Test Model 4

PMI Complex Test Case 4 MBD_0

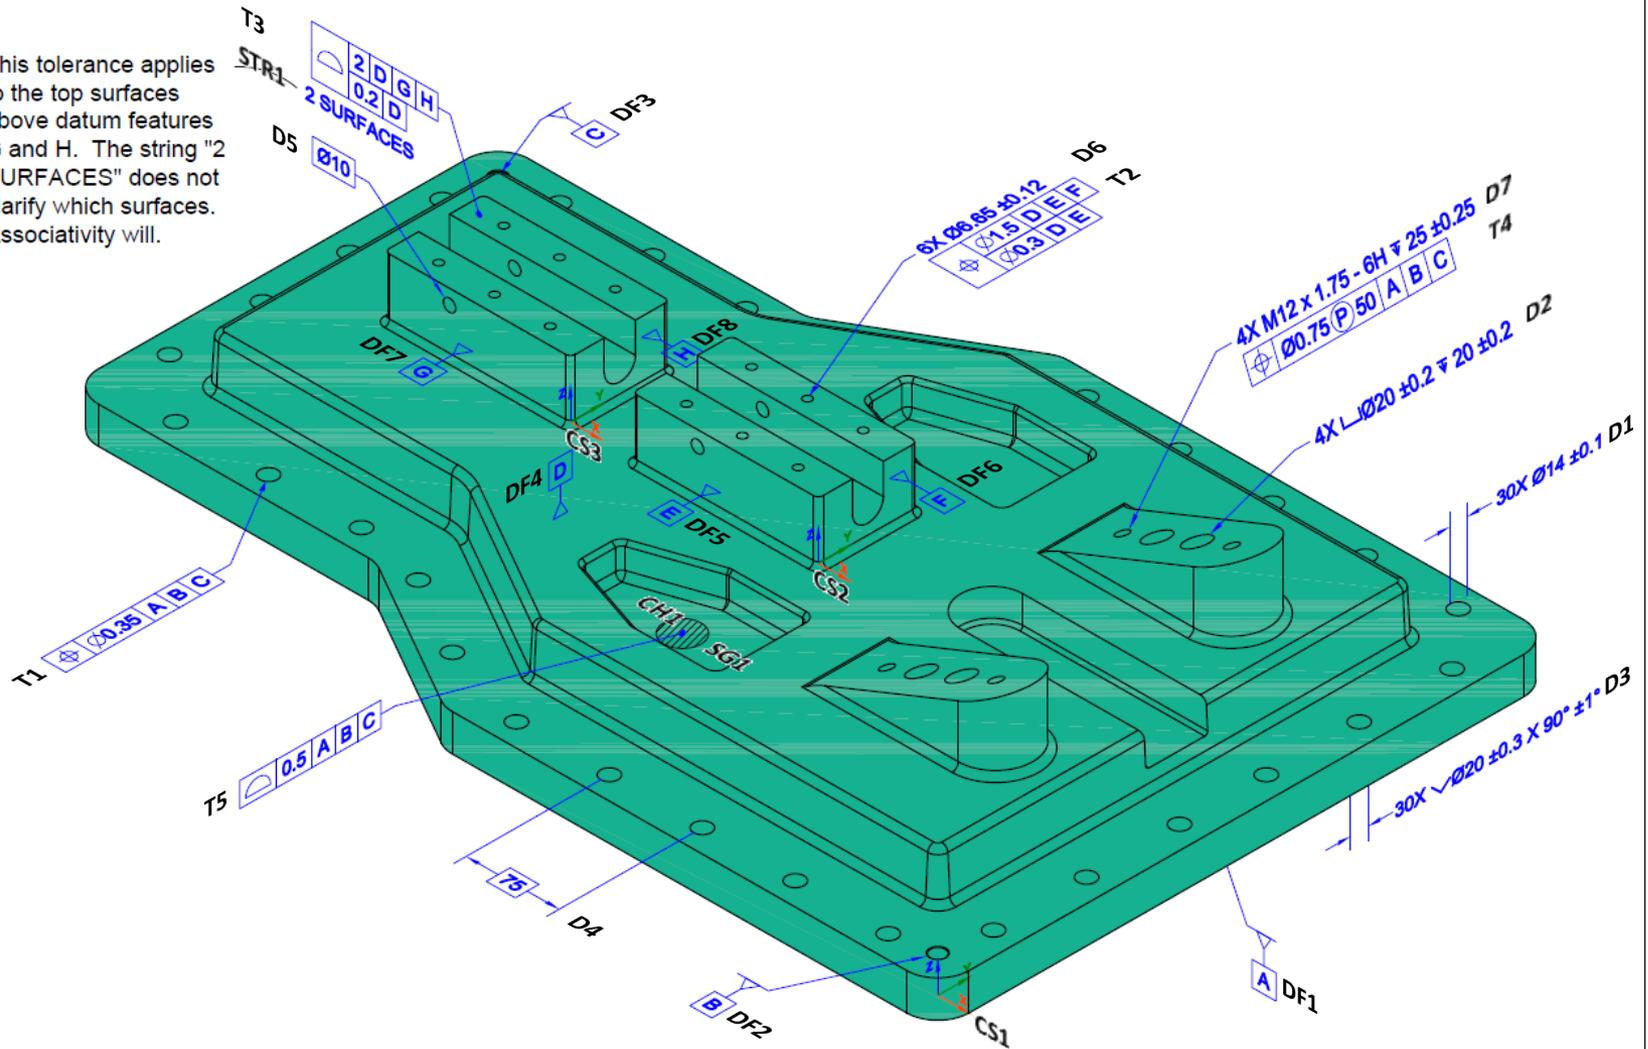
This tolerance applies to the top surfaces above datum features G and H. The string "2 SURFACES" does not clarify which surfaces. Associativity will.
